**PLAN COMMISSION
MEETING NOTICE AND AGENDA
Thursday, July 18, 2024
6:00 PM**

REPORT TO THE PLAN COMMISSION

Project Name: Comprehensive Master Plan Amendment, Rezoning, Certified Survey Map, and Site & Building Plan Review

We appreciate the opportunity to present a revised site plan to the City after the previous Plan Commission meeting on 6/20/24. In addition to the response letter provided to the City on 7/8/24 addressing comments received at that time, please accept the following narrative and voluntarily revised site plan for consideration of Uzelac’s new facility.

SITE PLAN C1.0

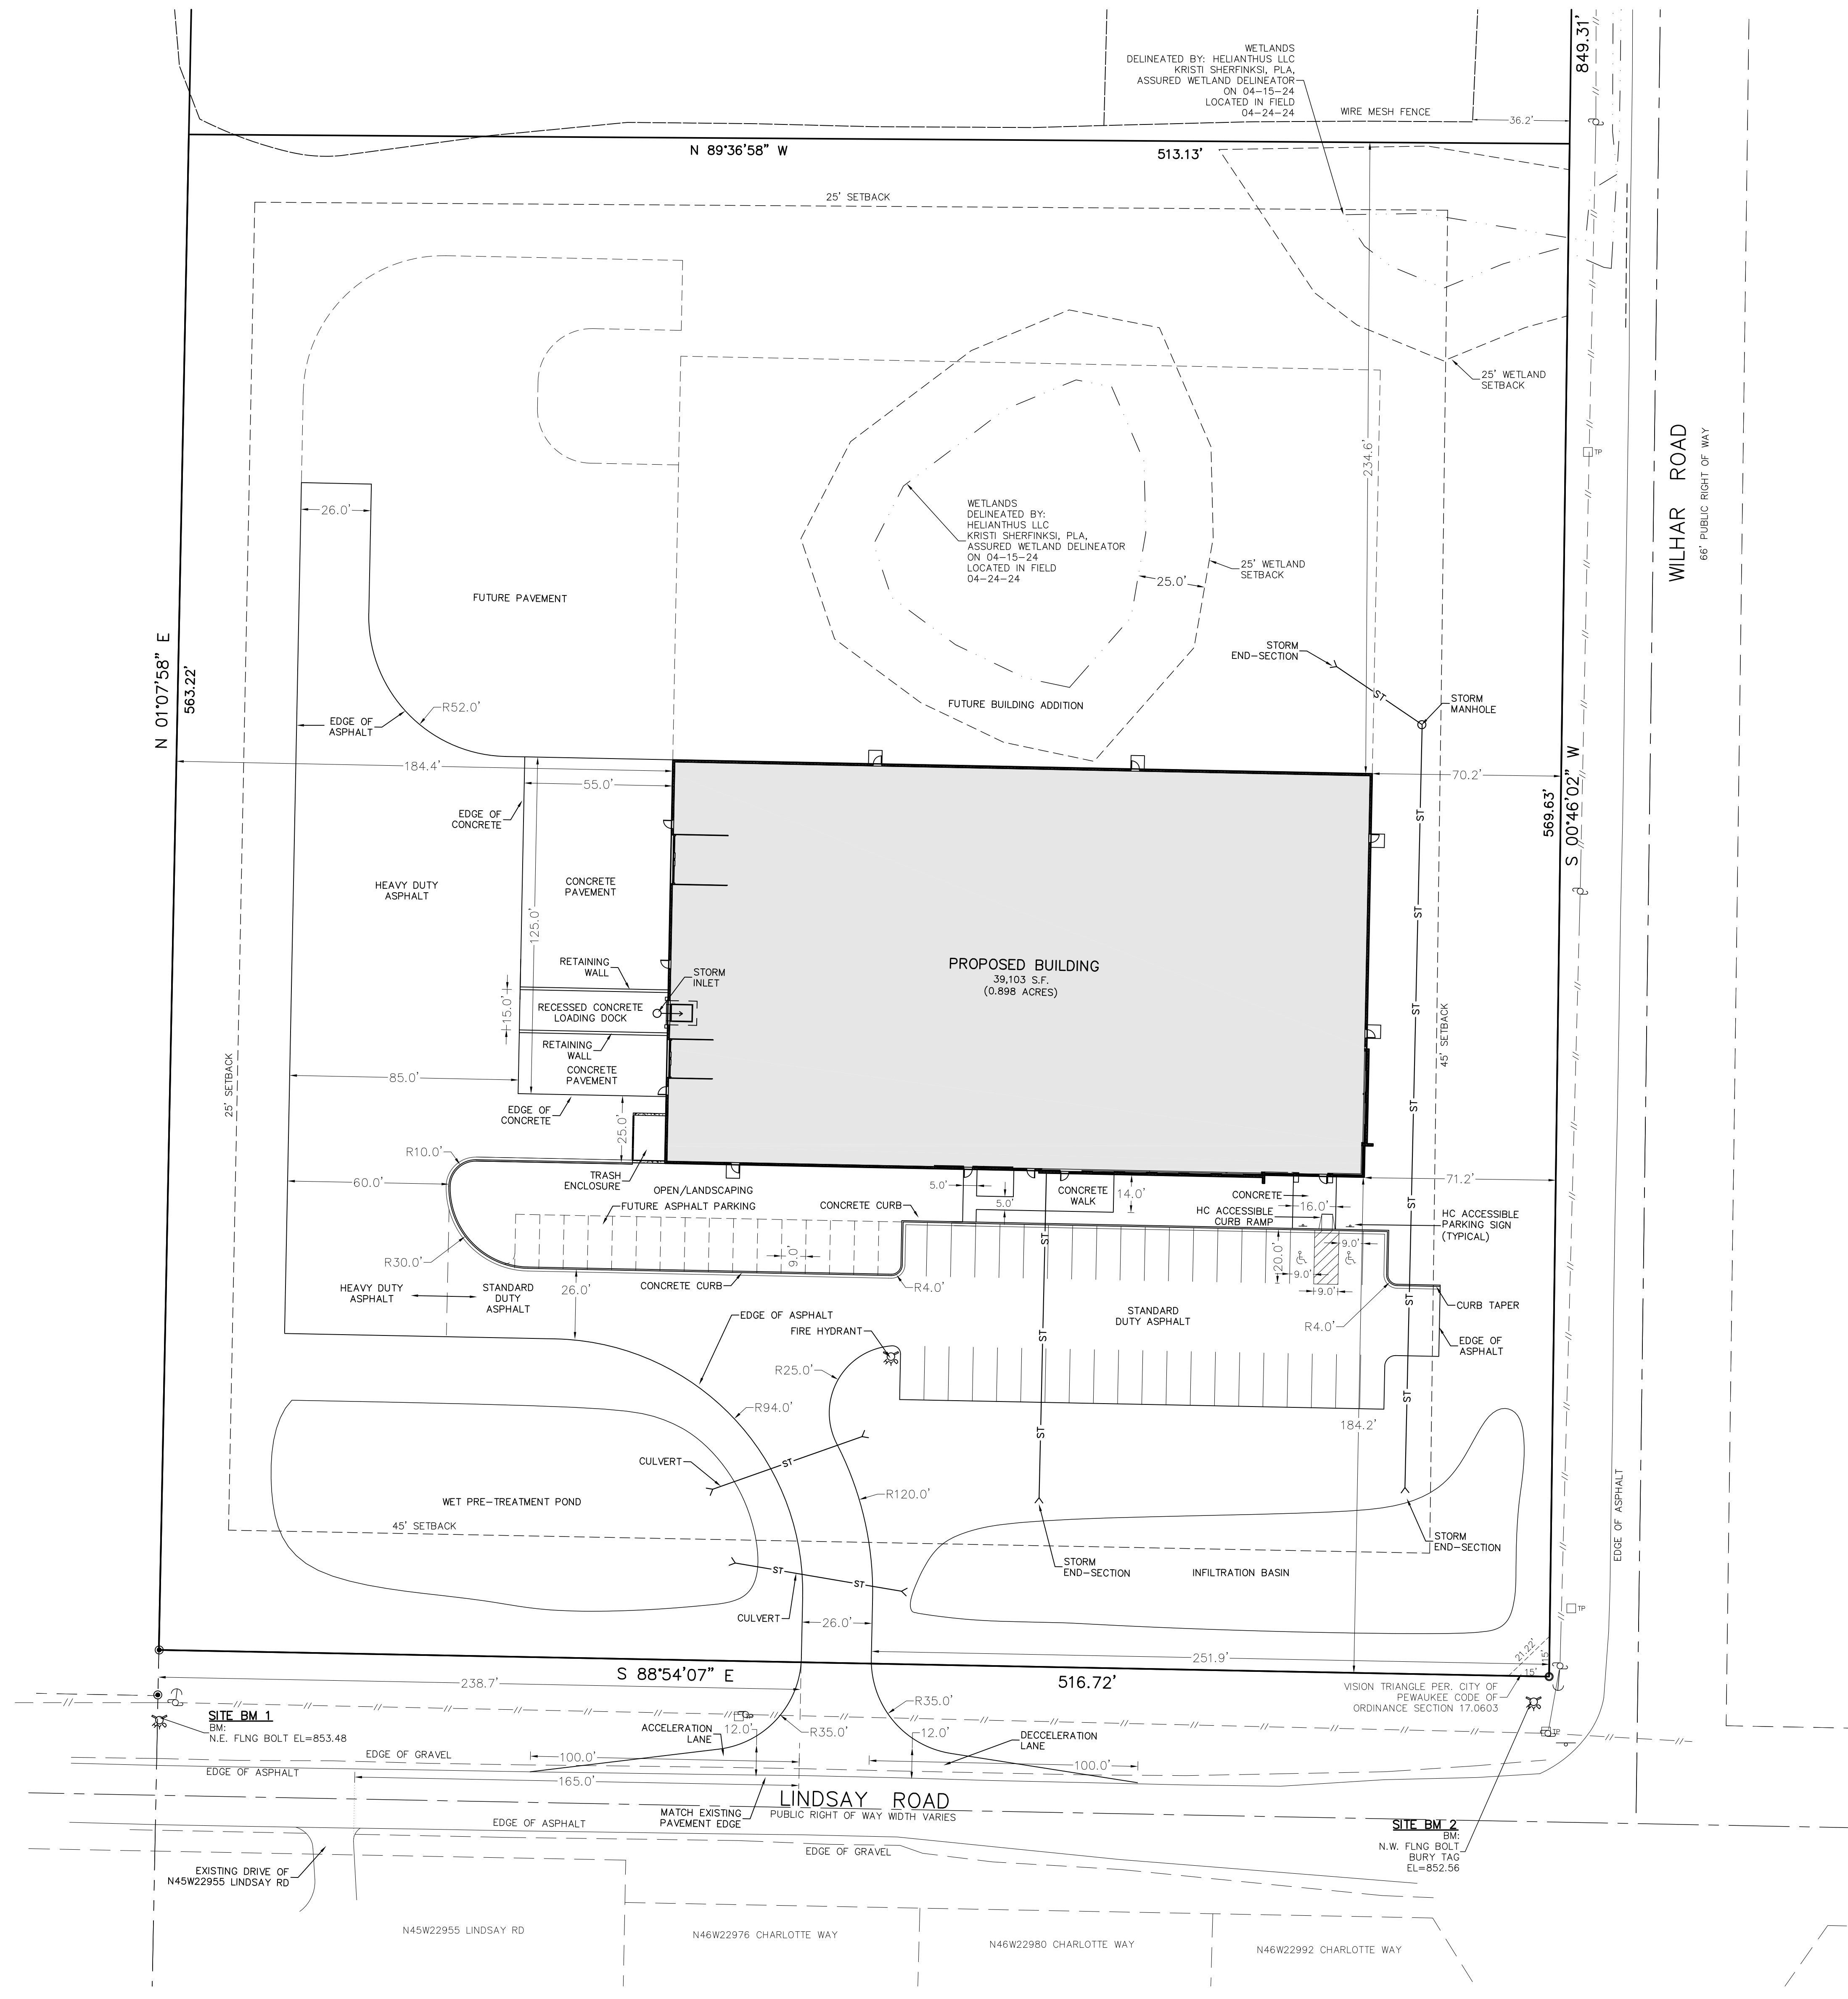
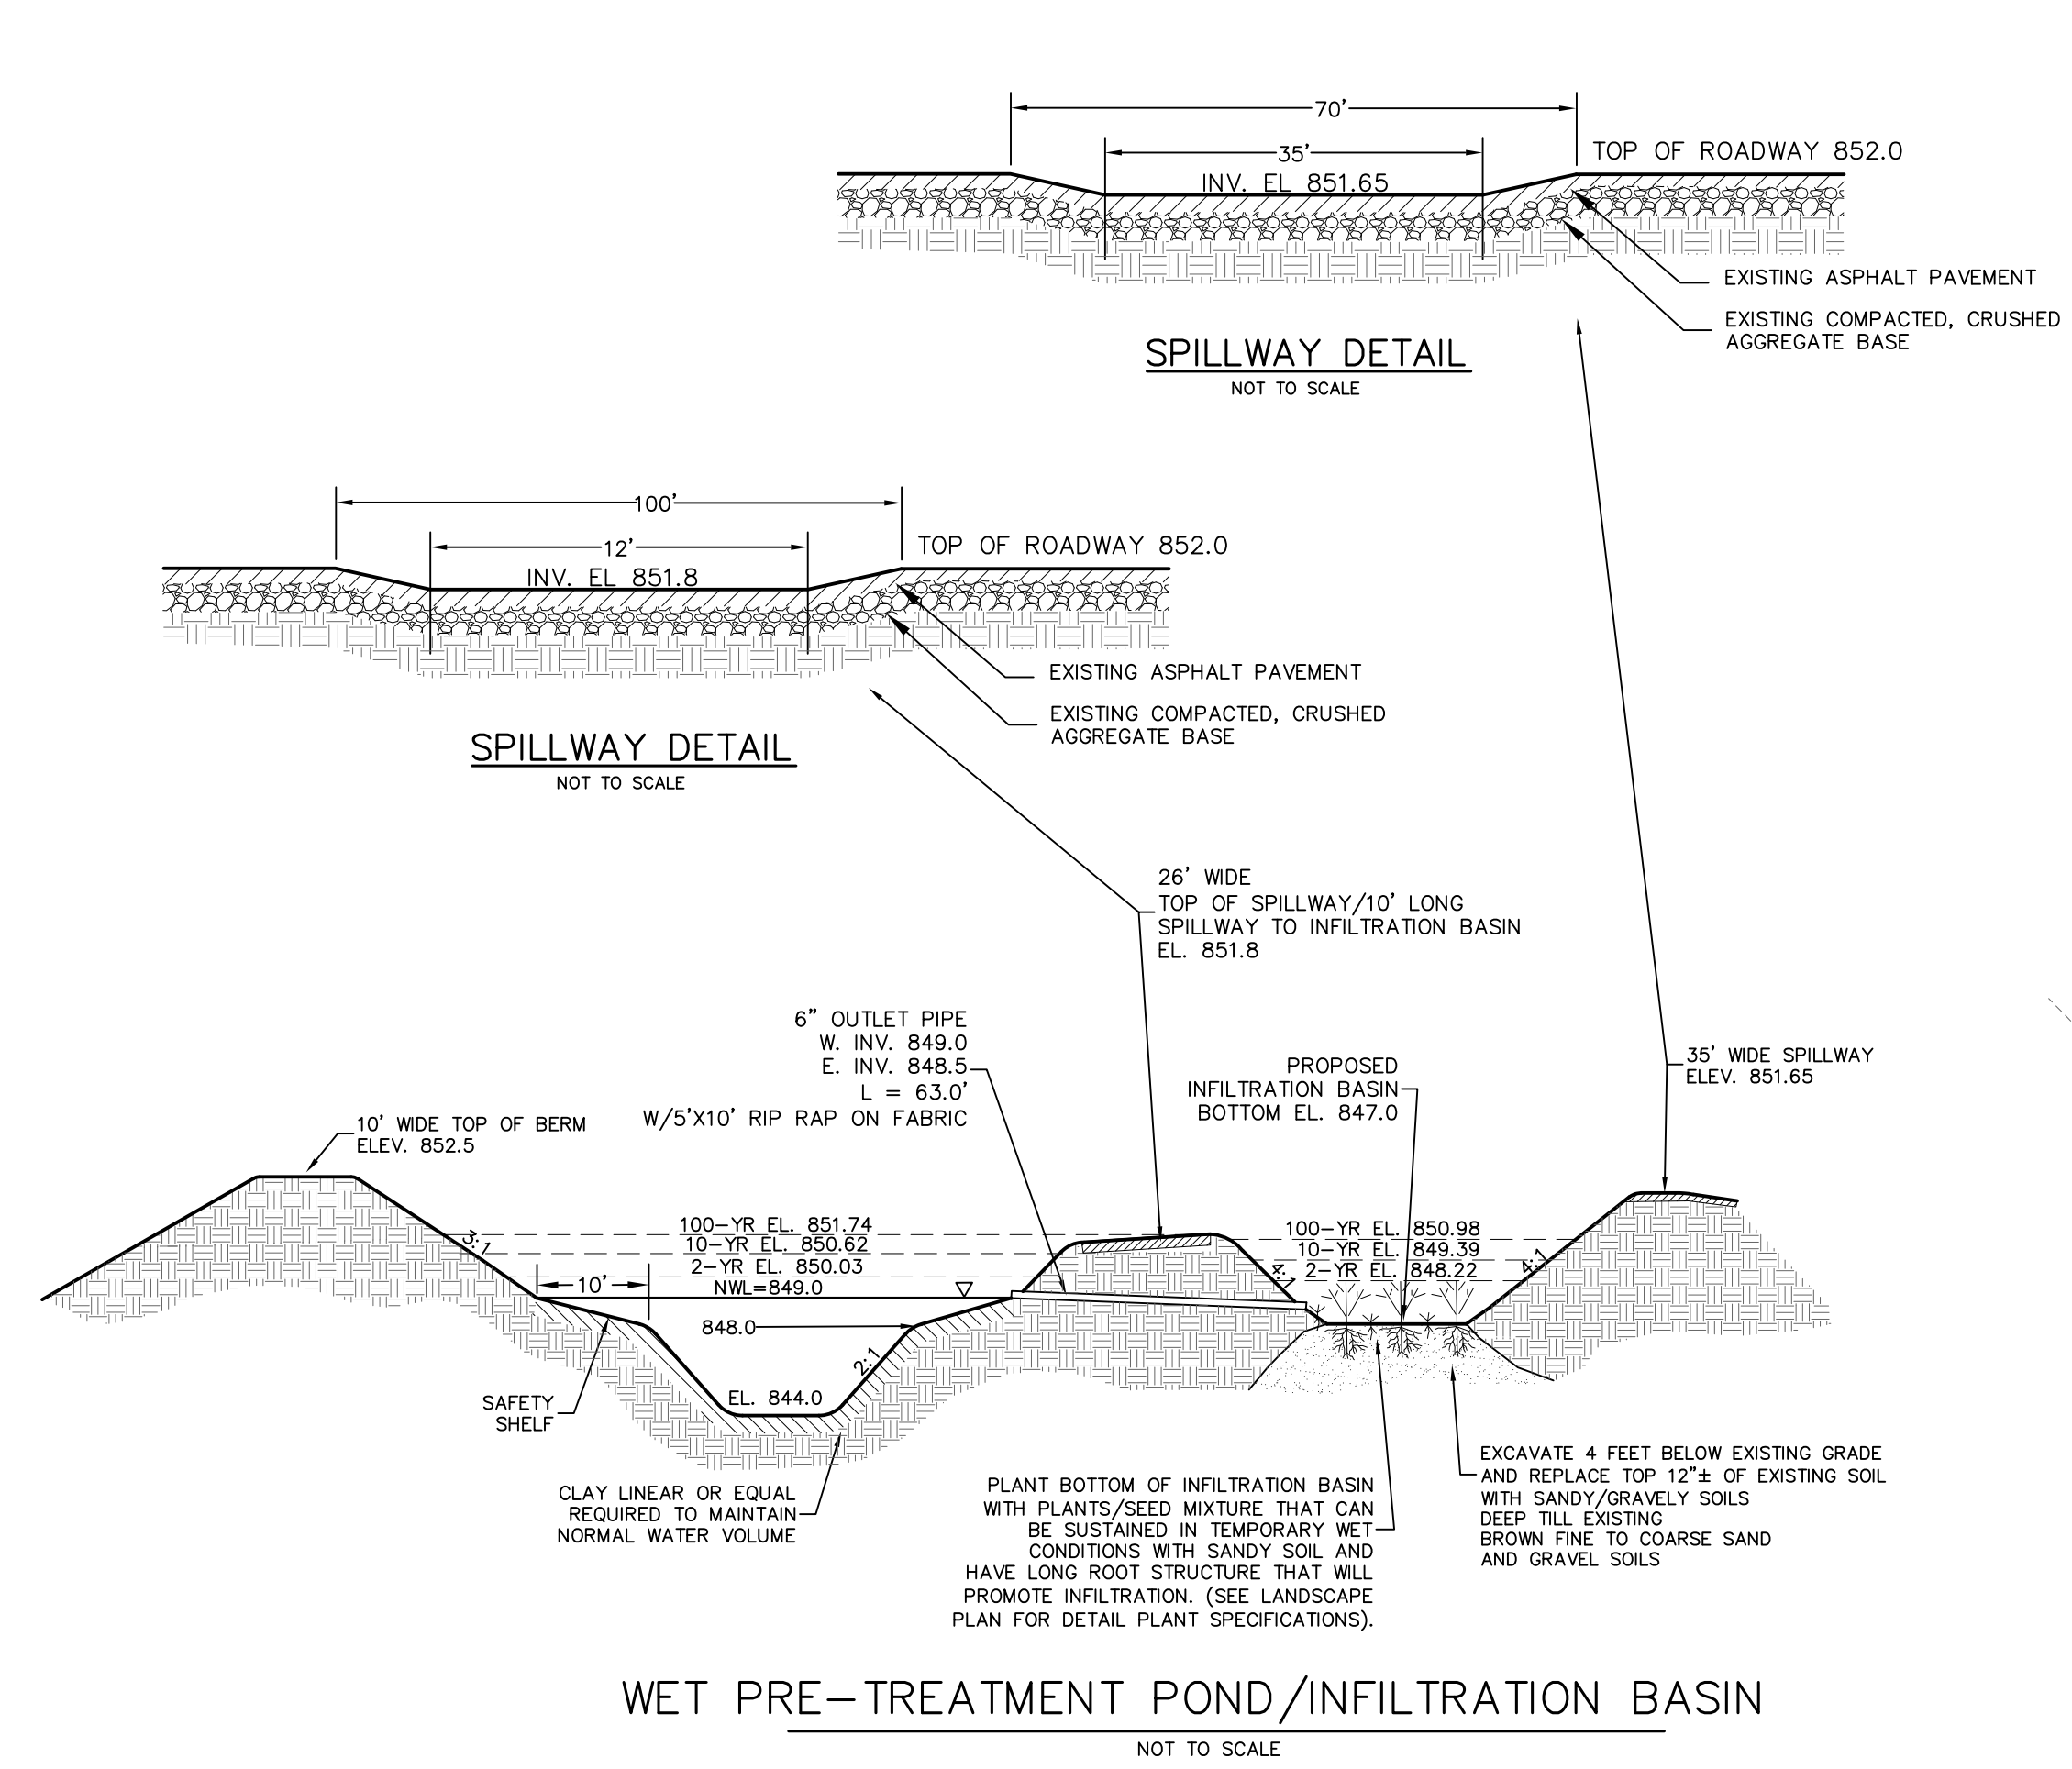
This change resulted in 39 parking spaces being proposed as part of the initial phase of development, opposed to 35 parking spaces as shown in the previous plan. Note that the number of future parking spaces is now reduced from 36 parking spaces to 16 parking spaces.

meaningful discussion at Plan Commission, the site plan was voluntarily revised to accommodate the well-being of the surrounding community by condensing access to one driveway off Lindsay Road and relocating the proposed ingress/egress driveway to the east 165 feet. This proposed revision avoids any and all further impact to Wilhar Road which was rated a 2 out of 10 level of service at the time of the public hearing. Additionally, relocating the driveway safely avoids conflict with private drives and the subdivision entrance.

06 TREE PROTECTION NTS

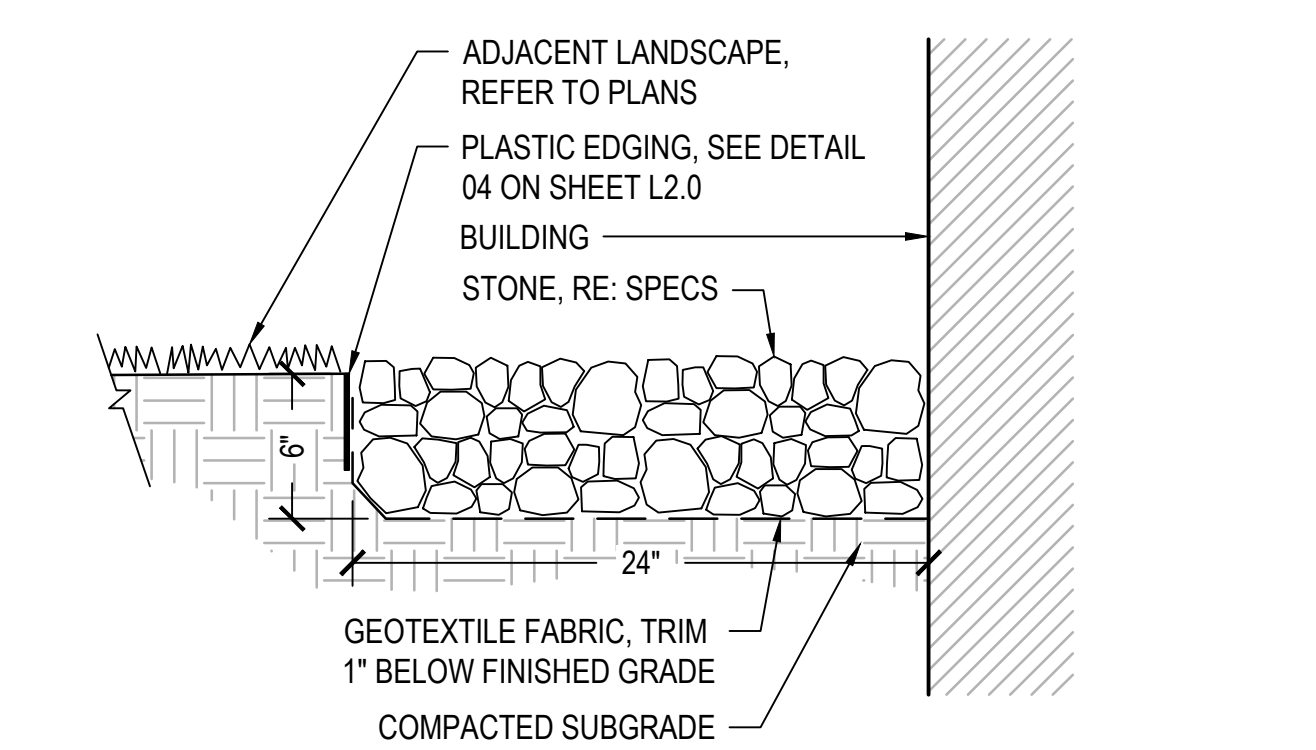
The applicant is also preserving existing trees located in the southwest corner of the property, which were previously shown as being disturbed. This area is shown on Sheet L1.0.

Landscaping: The revised plan clearly identifies an area of approximately 2,386 SF in the southwest corner of the proposed Development which will protect all existing trees, unless dead, per Tree Protection Detail 06 on Sheet L2.0. Additional evergreen screening is shown between the proposed truck loading area and the wet pre-treatment pond. An emphasis was placed on creating an attractive, vegetative buffer from Lindsay Road to ensure the surrounding community is minimally impacted by light pollution.
